**To:** Cambridgeshire County Council General Purposes Committee  
**Authors:** Richard Cushing and Edward Leigh, Smarter Cambridge Transport  
**Subject:** Review of Capita report and recommendations on guided busway defects  
**Contact:** 01223 312 377 / [edward@smartertransport.uk](mailto:edward@smartertransport.uk) / [@SmarterCam](https://www.facebook.com/SmarterCam)

# Cambridgeshire Guided Busway Defects

Figure 1: Cross-section of the busway showing a typical 15m 'ladder section' and one of three shallow foundations.

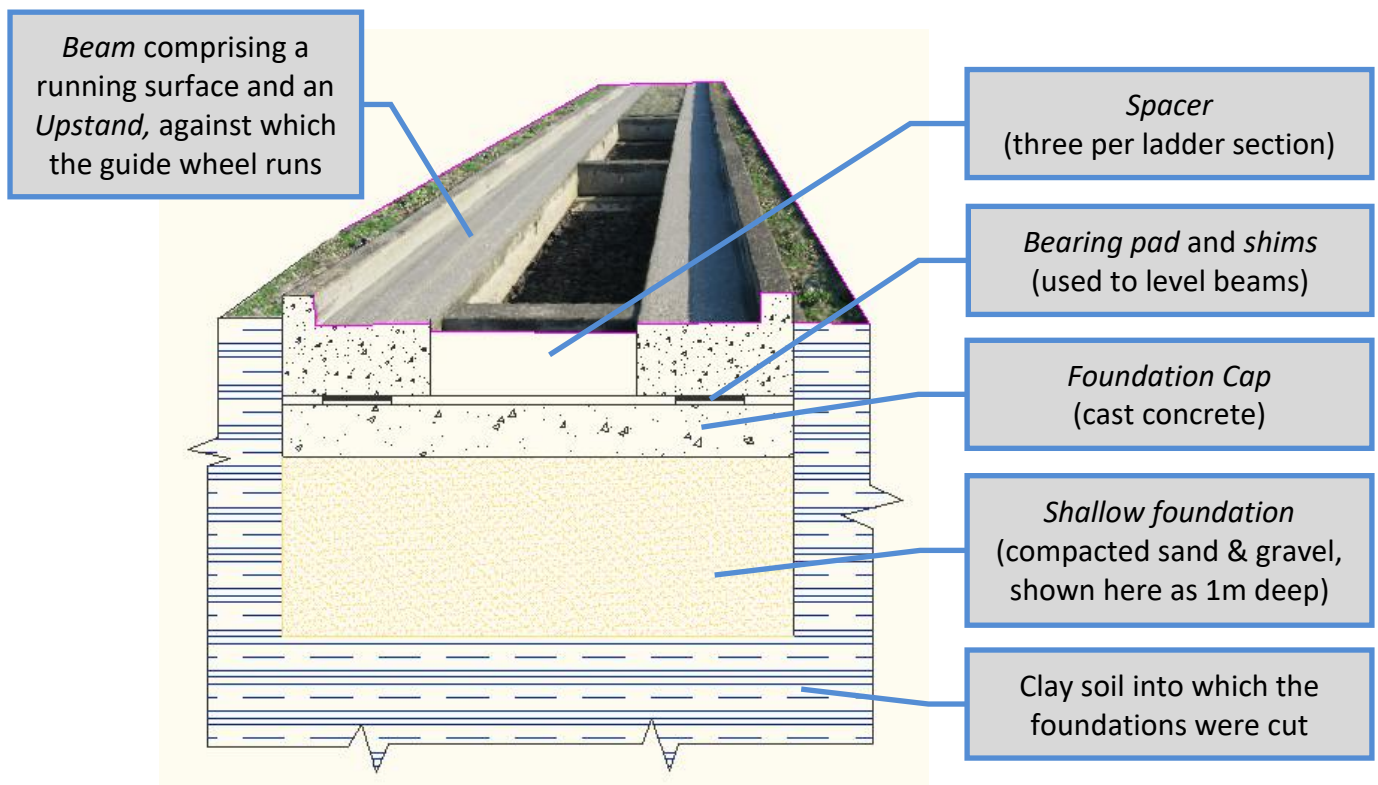
*What analysis has been carried out to quantify the risk of derailment (e.g. owing to a beam up-stand breaking away under load, or a guide wheel riding up a damaged beam end)? Has the effect of derailment been modelled for a double-decker bus, in particular on a section where the centre of the guideway is open or in-filled with loose rubber, as shown in Fig 1 below?*

Figure 2: Shallow foundation [2-Fig 7]. 821 of these are to be re-excavated, deepened and re-instated

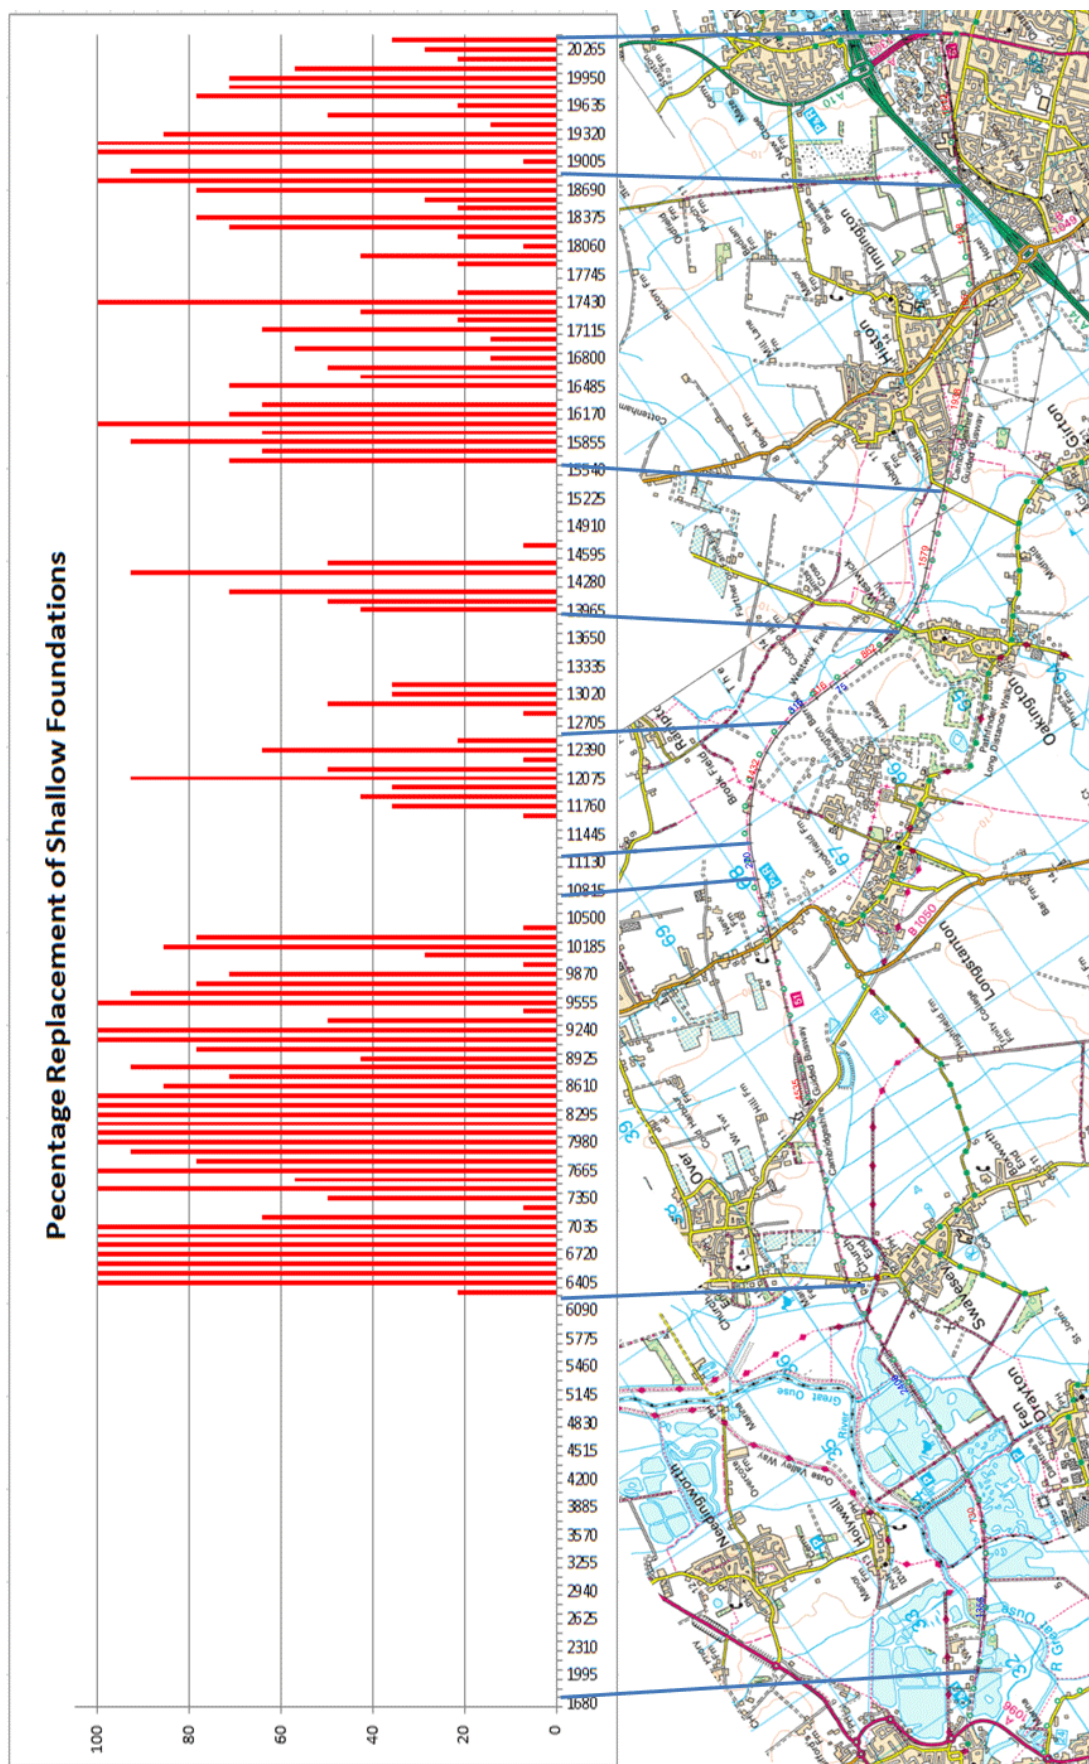
The size of the 'shallow' foundations are noted in the 2014 report [1 – p7, Fig 7], reproduced above (Fig 2). It would appear from the photograph that the volume of material present in such a foundation would require several journeys by heavy vehicles to remove it. The report notes that 821 of these foundations are to be excavated, deepened and re-established, using compacted Class 6N fill. It is unclear whether all of the excavated material will be removed from site and fresh material brought to the site, or whether some of the original material may be re-usable.

Consequently, there appears to be no indication of the number of vehicle movements which will be required to accomplish this or any of the other tasks. Nor is there any indication of the disruption to local villages caused by heavy vehicle movements, or any other indication of the environmental impact on the locality.

Furthermore, the foundation pit is formed in clay. The clay has been compacted by many years of supporting the track bed of an old railway line. It is suggested that this clay will be relatively impervious. Surface water draining into the foundation pit will have little opportunity to escape. As a result, the pit will remain filled with a slurry of loose fill and water. When vehicles load the foundation cap, the slurry will be pumped outwards, potentially causing erosion of the sides of the pit, and subsequent partial collapse.

***How many heavy vehicle movements will be required to dispose of material excavated from the foundations, and how many more will be required to bring fresh material onto the site? Has any consideration been given to the overall environmental impact of carrying out the remedial work proposed in the 2016 report [2]? If so, could a copy of the assessment be provided?***

Figure 6a: Front wheels load the beams above the bearing points.

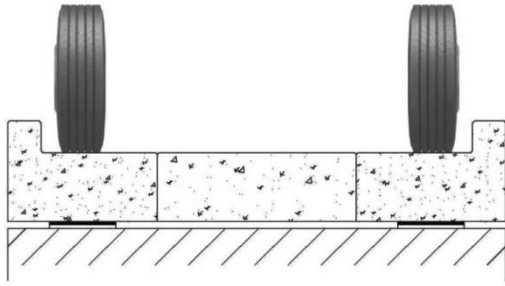
Figure 6 indicates the loading from front (single) (Fig 6a) and rear (double) wheels (Fig 6b). It will be seen that the bearings directly support the load on the front wheels. However the rear wheels put a load inside the bearing and shim stack. The inner edges of the beams roll away from the spacers; the through bolts stretch and allow the beams to push the beams outward. Friction between the foundation block, bearing, shims and beam is not sufficient to constrain the movement.

Figure 6b: Rear wheels create an offset load on the bearing stack, causing the beams to roll. This puts stress on the beams, spacers and fixings, and tends to force the stack outwards as shown below.

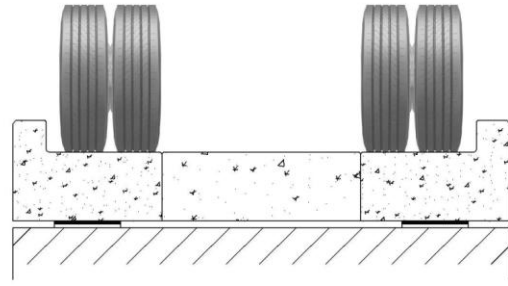
***It appears that vehicles with twin wheels (typical on the rear axle) are likely to cause the beams to roll inward as the vehicle passes along the guideway. In the suggested repairs to the Busway, has any account been taken of the possibility that the bearing area is not large enough to support the beams, and of the potential degradation which this may continue to cause?***

Figure 8: Indicative profile of the ride for extended sections of the Busway. The observed motion of the vehicle will differ from the profile of the beam, having been modified by the vehicle suspension.

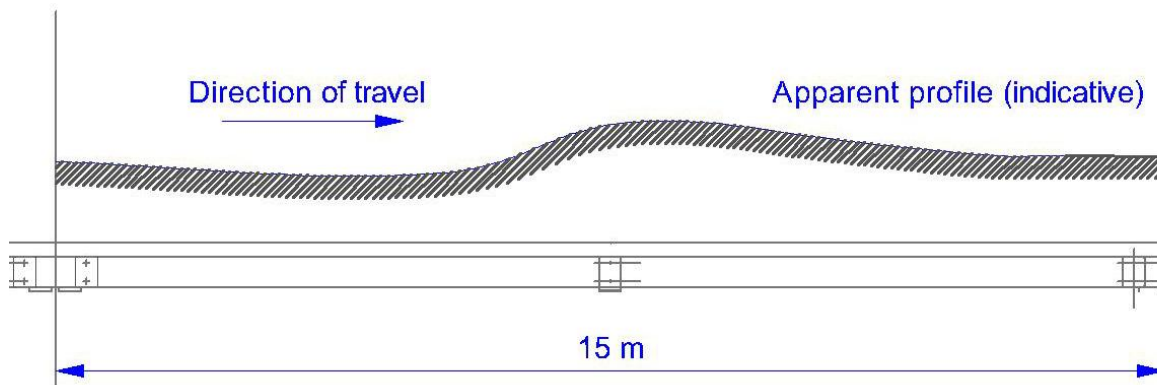
Whilst each shock wave is relatively small, the cumulative effect of some eighty axles per day (28,000 per year) is likely to have a distinct effect upon every element of the structure. Along several sections of the Busway when running at speed a poor ride quality is noticeable – the bus is lifted sharply and on a regular basis as though hopping. These uplifts apparently occur at

15 m intervals and at the centre point of the beam. This is consistent with the centre foundation being higher than those at the ends which are under the joints.

***Has any consideration been given to the cause of the poor ride quality along significant sections of the Busway, and in particular whether variation in height of the foundations may be due to percussive loading at the joints of the beams?***

Figure 9: Action and reaction of a beam as it receives an impact from a loaded wheel.

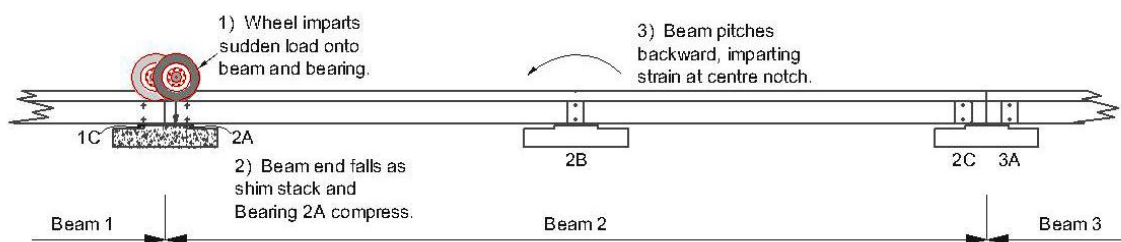
With an 18 tonne dual axle bus approximately 3.5t is taken on each of the front wheels. With the wheel at the end of Beam 1, the load on 1C is a total of 7.3t (beam with bus), and the load on 2A is 3.8t (beam alone).

When the wheel crosses onto Beam 2, the situation is reversed, and load on the bearing 2A suddenly increases from 3.8t to 7.3t. The shims and bearing will be flattened and compressed; the beam end receives a sharp blow (mitigated by the vehicle tyres) and will move downwards.

Bearing 2B is already loaded by half of the weight of the beam. It takes little of the additional weight of the bus, so initially the effect will be that the distant end of the beam rises, offloading 2C. The rotational torque is imparted by tension in the beam above the centre, concentrated around the V-notch.

**We suggest that a significant reason for cracking is cyclical percussive loading as bus wheels hit the start of each beam.**

Bearing 2A will take an impact load from the wheel. This will be imparted to the foundation through the shims and bearing. A small movement in the foundation slab will be imparted to

the underlying soil. By the time the rear axle arrives at this point the load from the front will be almost over the centre bearing, and Bearing 2A will have been substantially offloaded. The second axle of the bus imparts a percussive load of approximately 11t with even greater effect than the first.

It is not the purpose of these notes to quantify the movement. However, the effect is potentially cumulative. With forty vehicles per day, even a movement in the foundation block of 0.2 micron per axle will result in a total of approximately 6 mm per annum. This is small compared to some of the changes reported in the foundations.

**We suggest that a significant reason for differential settlement of the foundations is because of percussive loading by wheels as they impact the start of the beam. The loading on the centre foundation is much smoother by comparison.**
